CITY OF MADISON

PLAN OF PROPOSED IMPROVEMENT

N FRANKLIN AVENUE & LYNN TERRACE - ASSESSMENT DISTRICT 2025

CITY PROJECT NO. 15113
CONTRACT NO. 8766

DETAILS - LYNN TERR INTERSECTION GRADES	15113
N FRANKLIN AVENUE & LYNN TERRACE - ASSESSMENT DISTRICT 2025	MADISON, WI
MADES\GN\Projects\15113\CAD\Streets\15113EN-PnP.dwg CONTRACT NO.: 8766

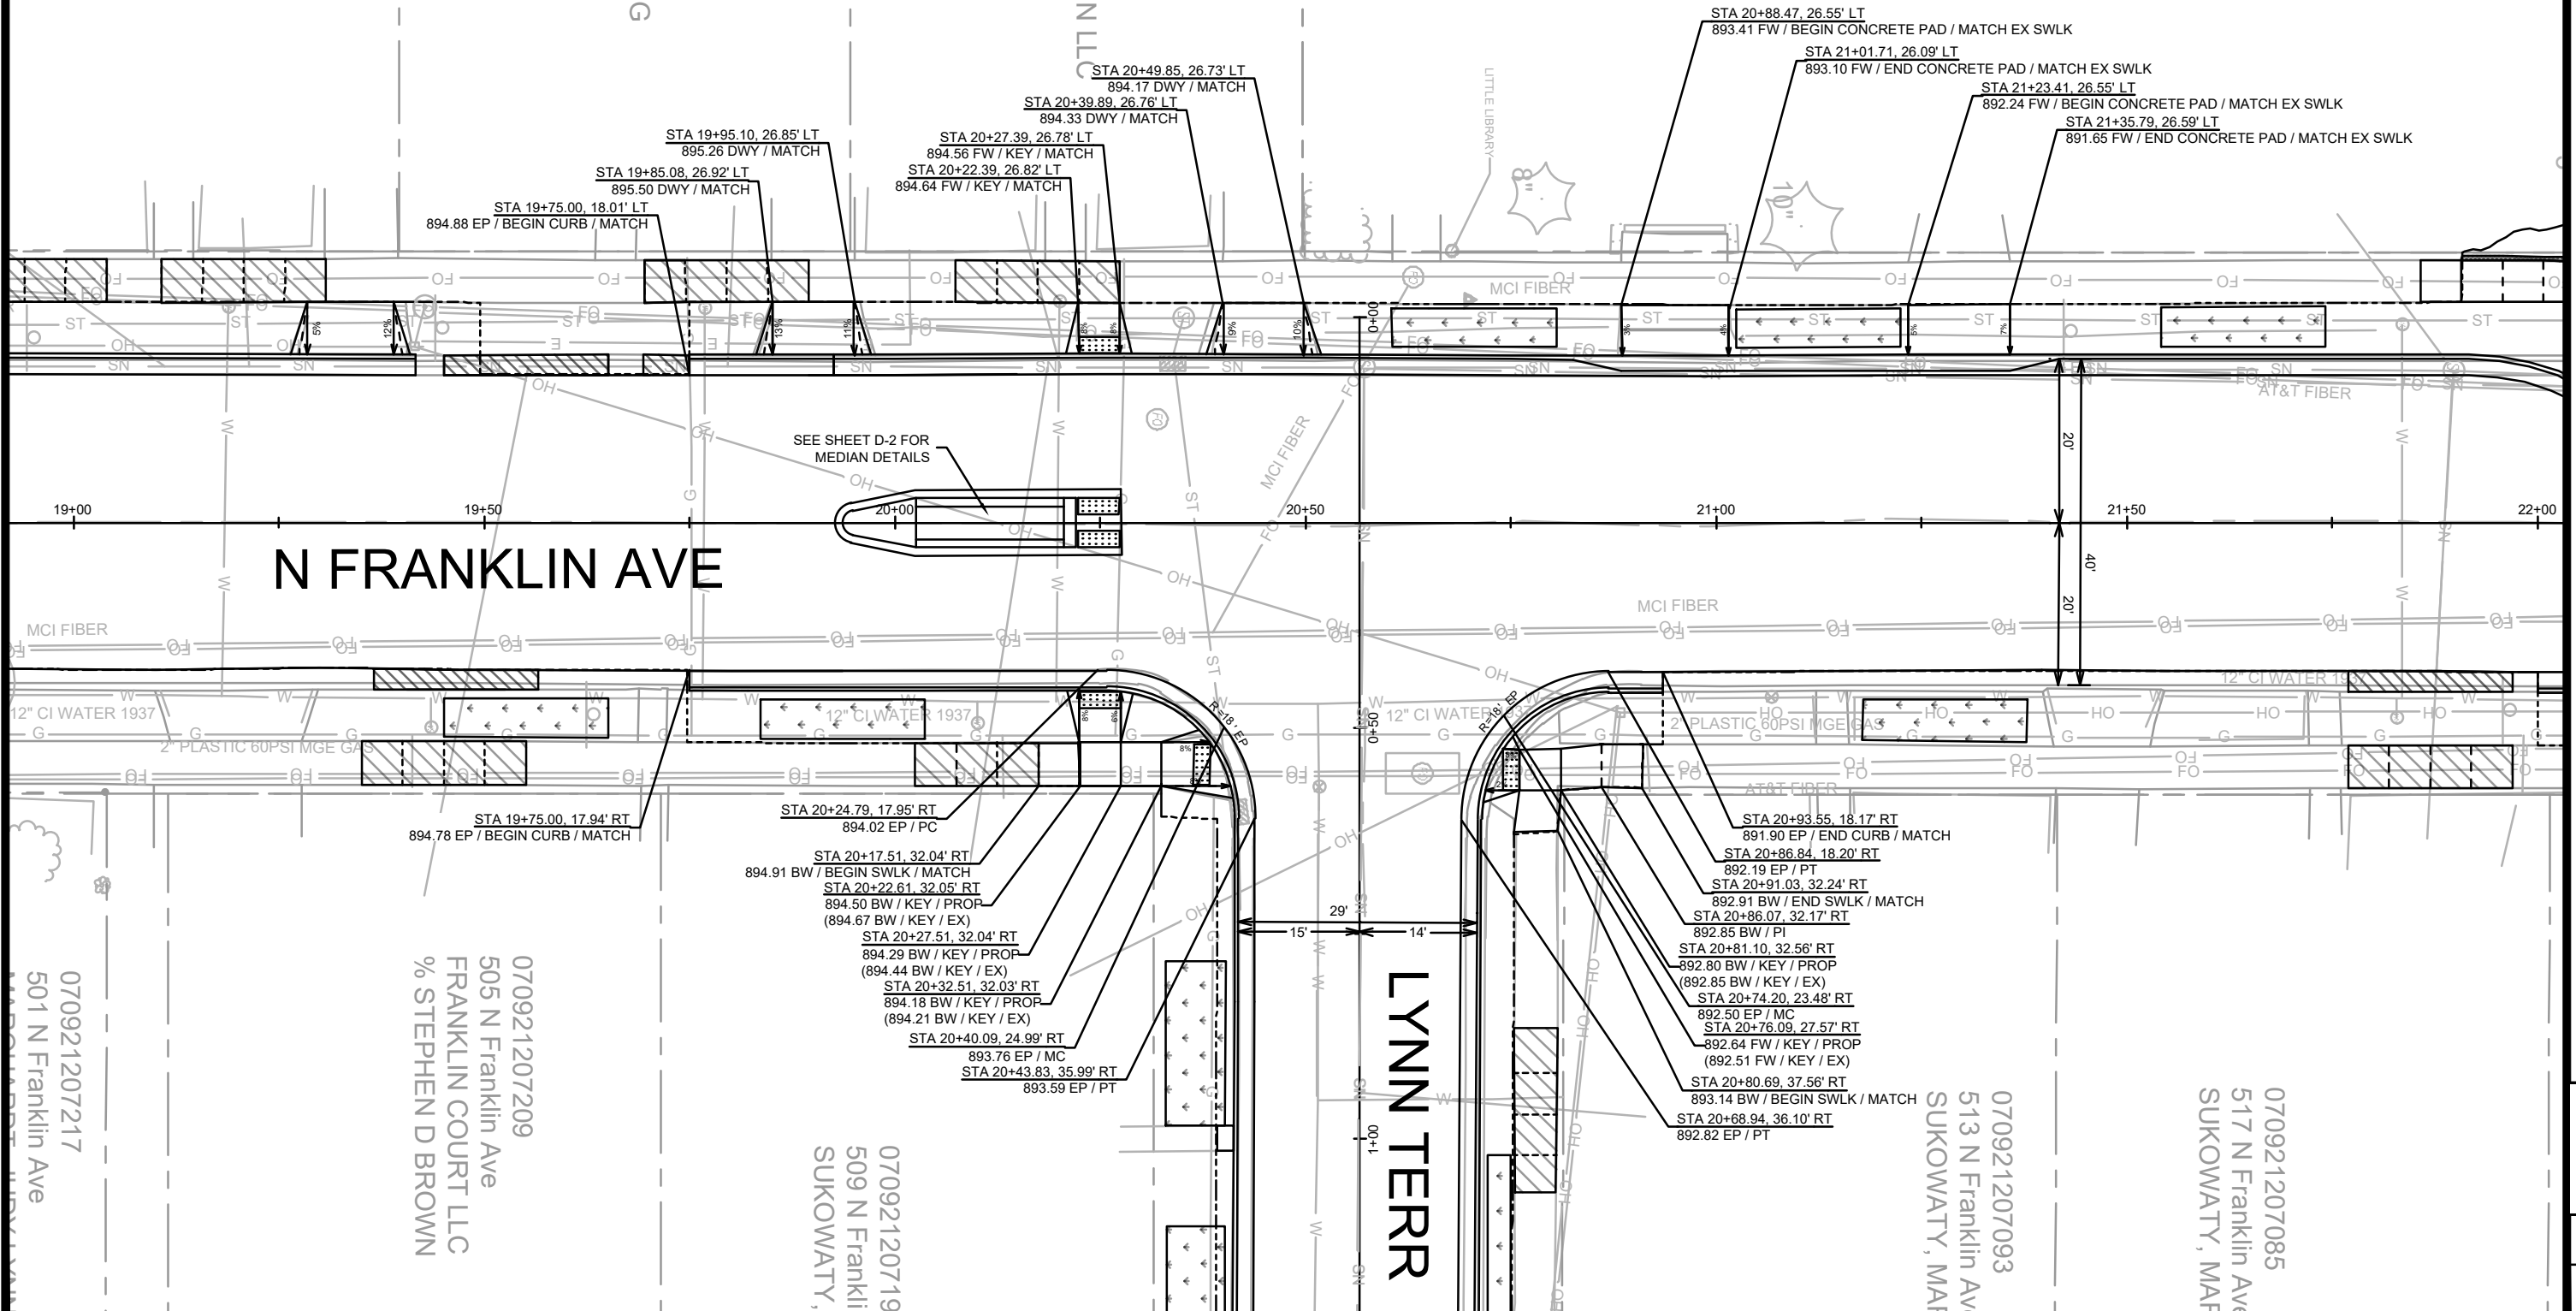
ADDENDUM 1 - GCIT - 02/11/25
- UPDATED INTERSECTION GRADES

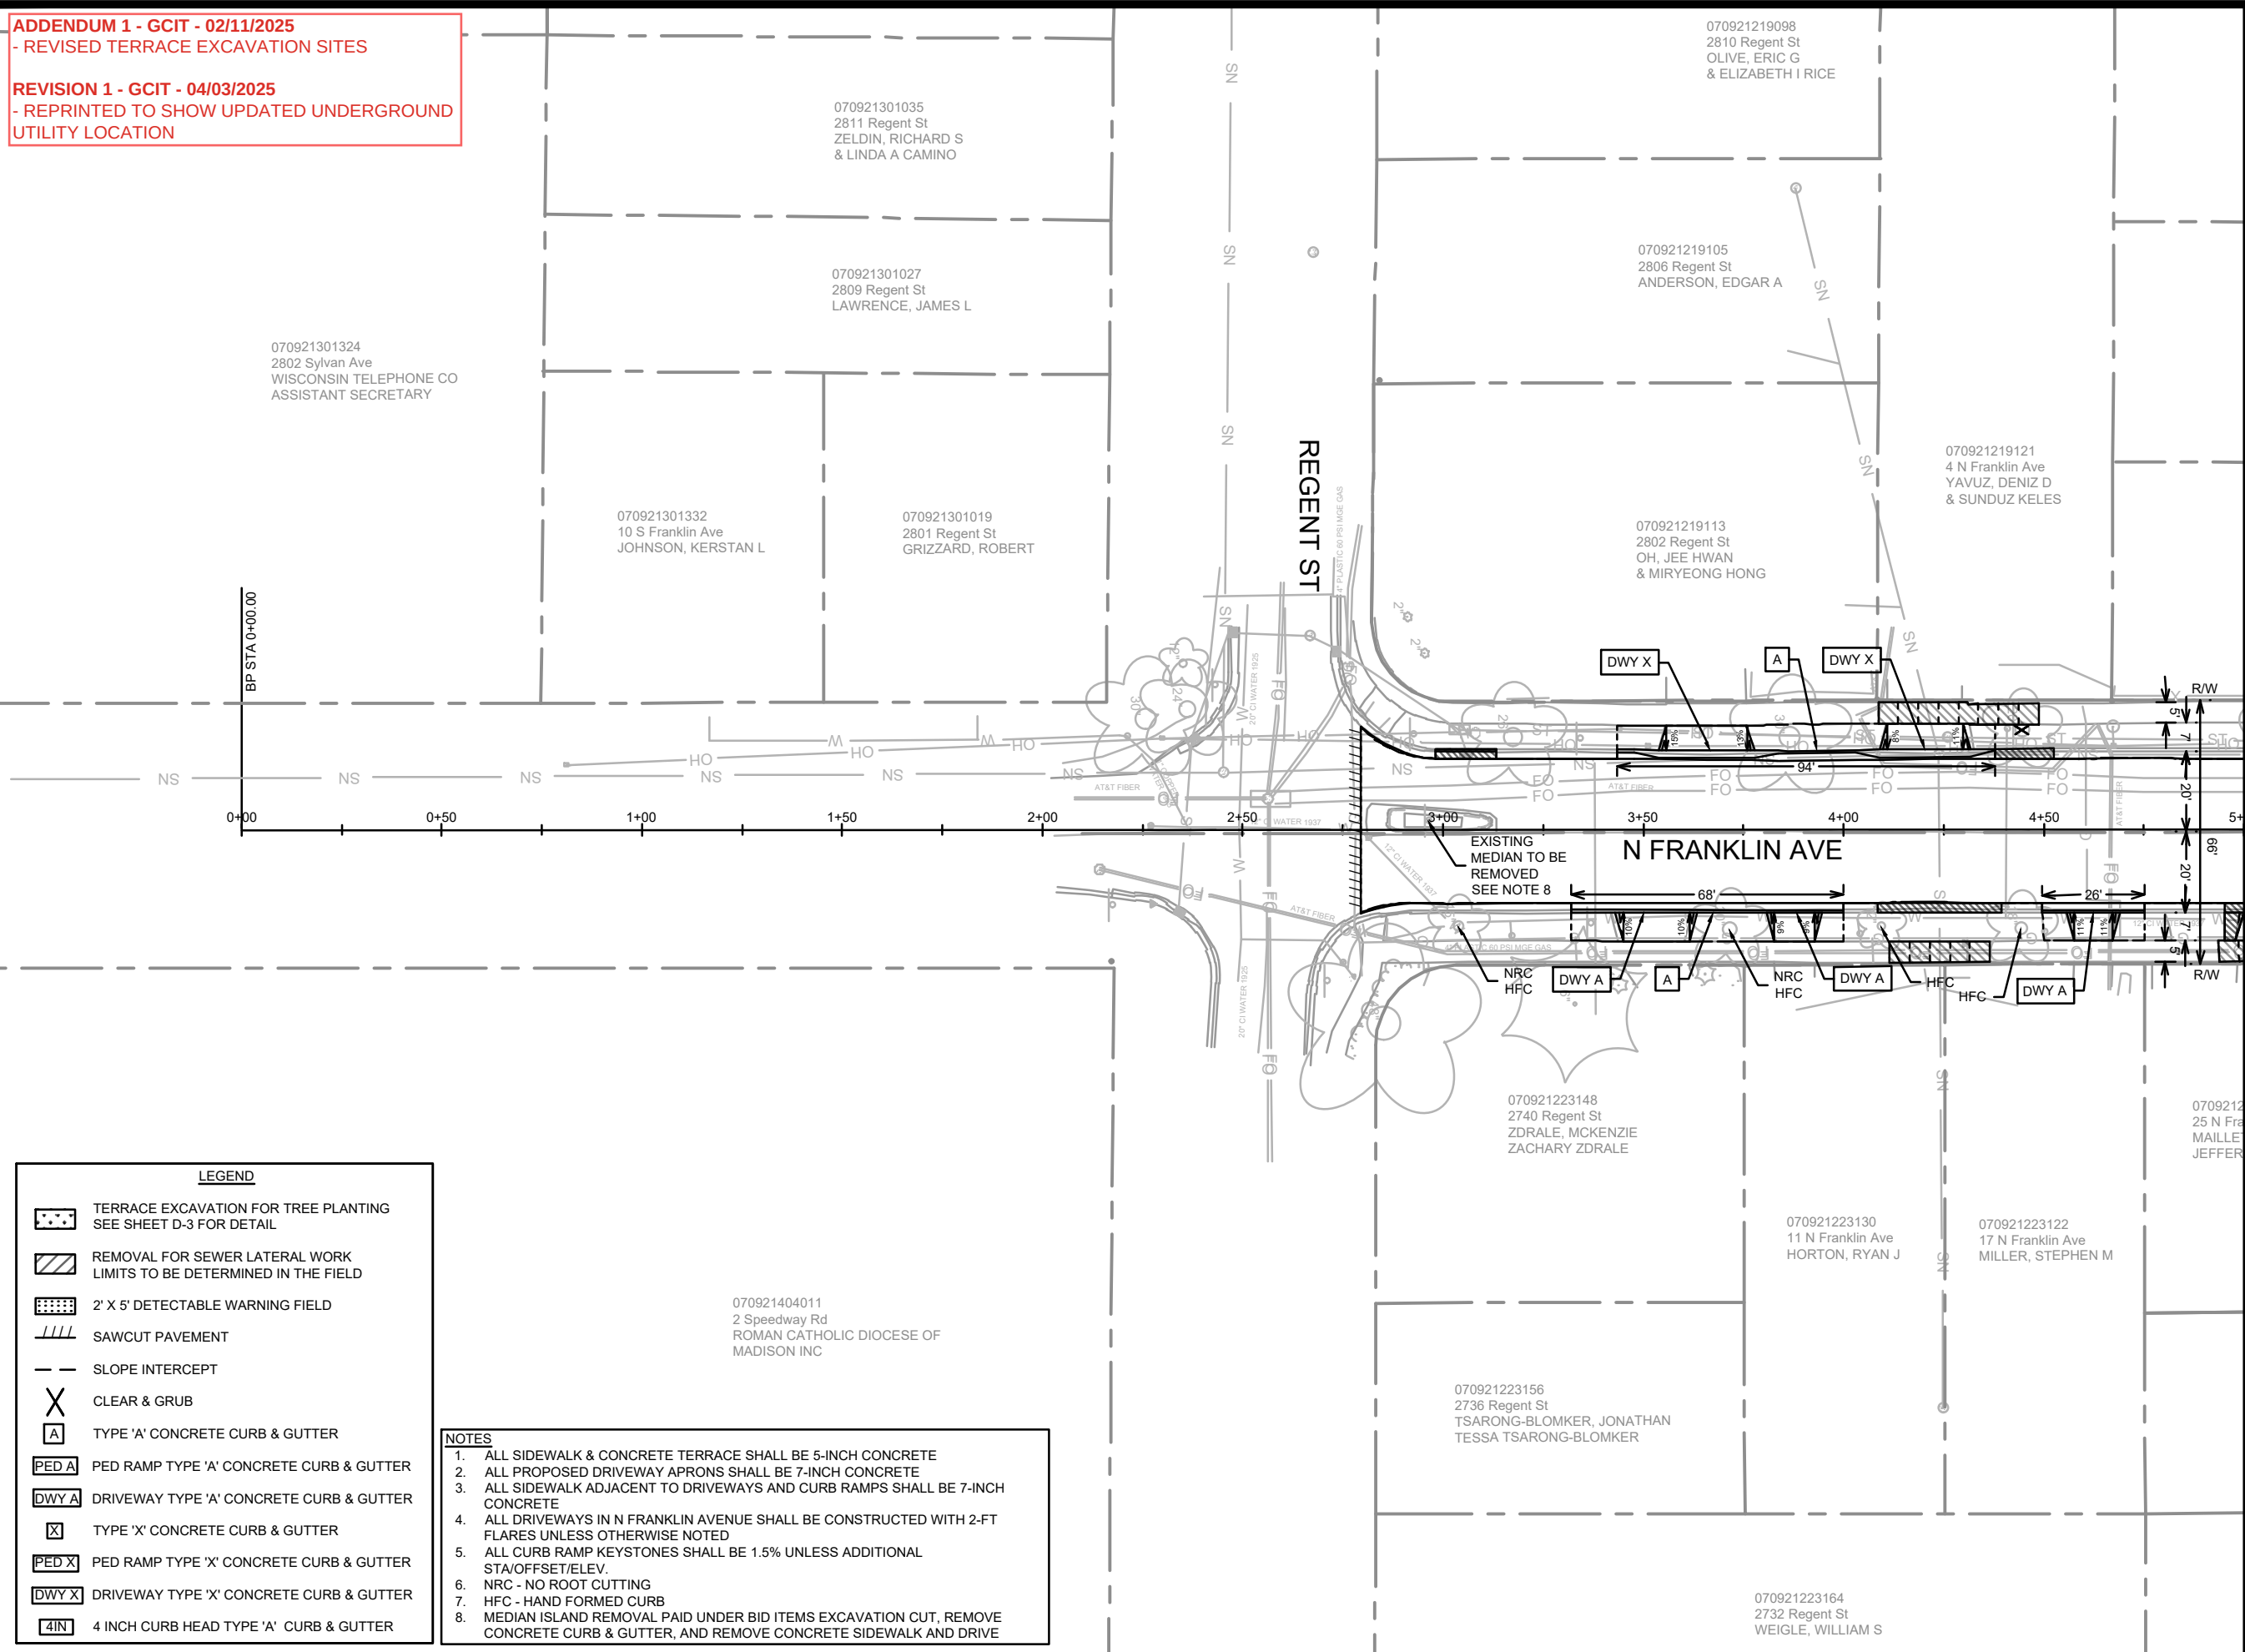
ADDENDUM 1 - GCIT - 02/11/2025
- REVISED TERRACE EXCAVATION SITES

REVISION 1 - GCIT - 04/03/2025
- REPRINTED TO SHOW UPDATED UNDERGROUND UTILITY LOCATION

REVISION 1 - GCIT - 04/03/2025
- REPRINTED TO SHOW UPDATED UNDERGROUND
UTILITY LOCATION

15113	ADD1	UPDATED TERRACE EXCAVATION SITES	02/11/25	GIT
Designated By: GCIT	REVISION	DATE	BY	
Date: 2/7/2025 11:55 AM				PD-4
Scale: 1" = 40'

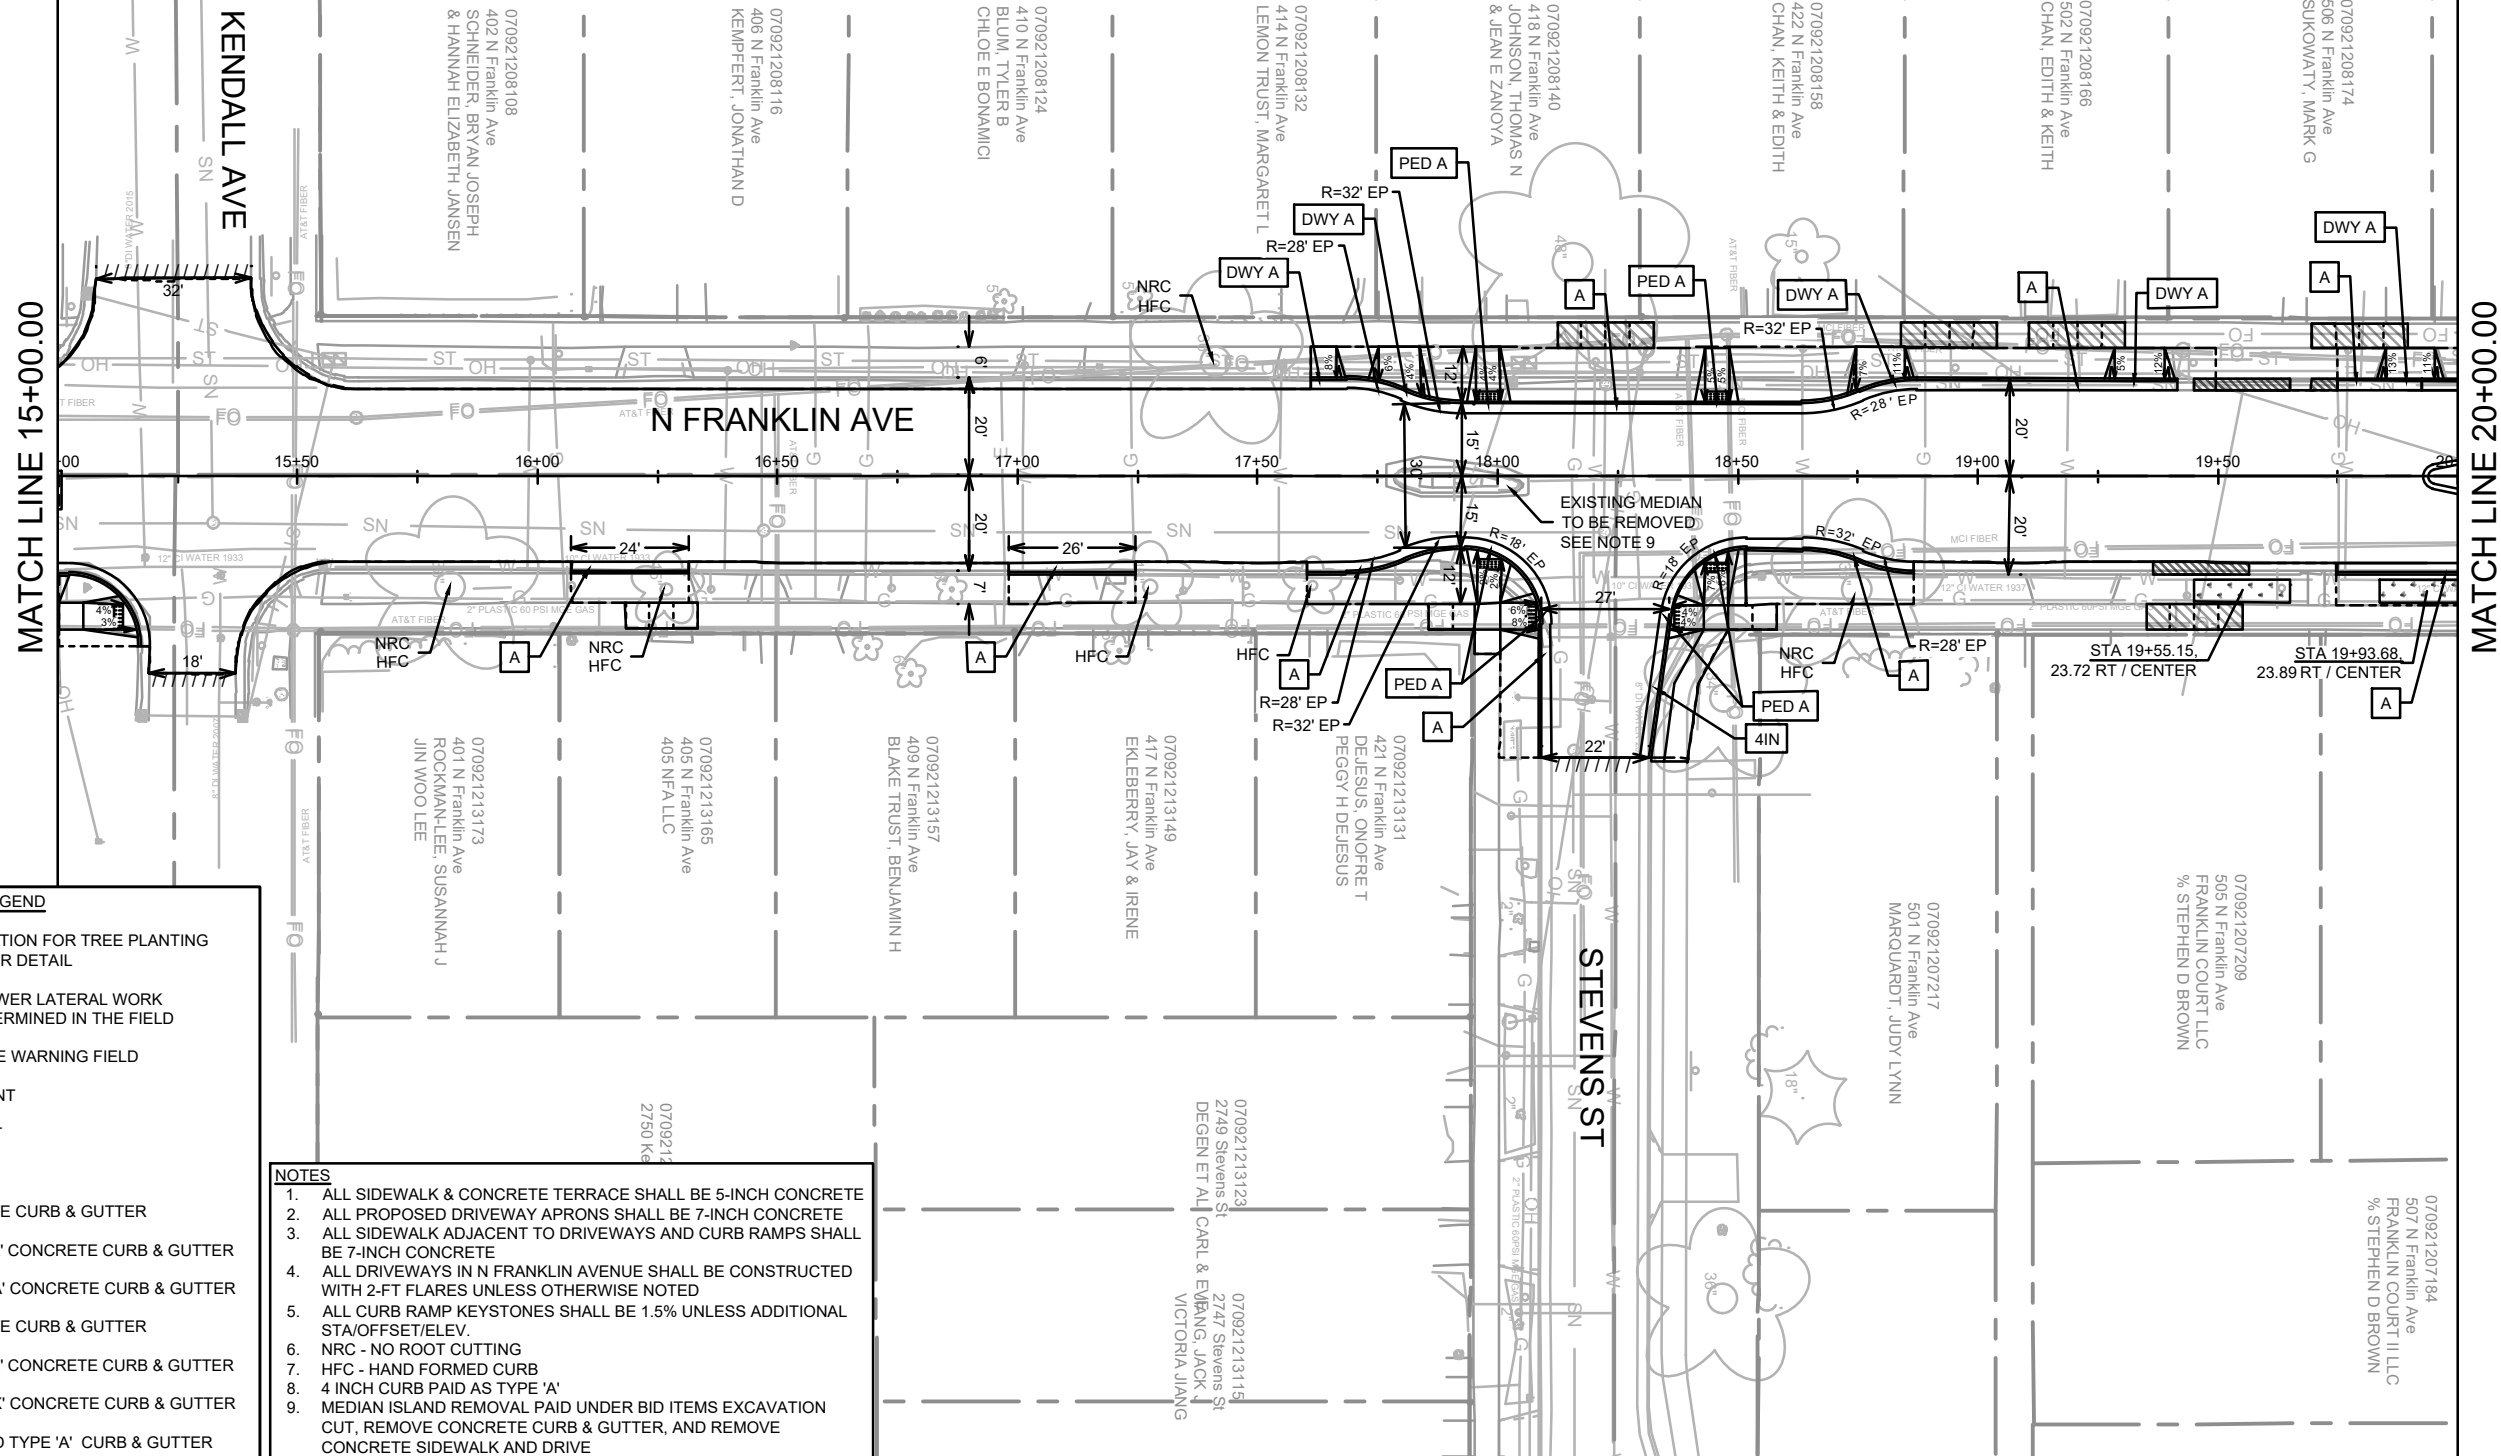
ADDENDUM 1 - GCIT - 02/11/25
- REVISED TERRACE EXCAVATION SITES
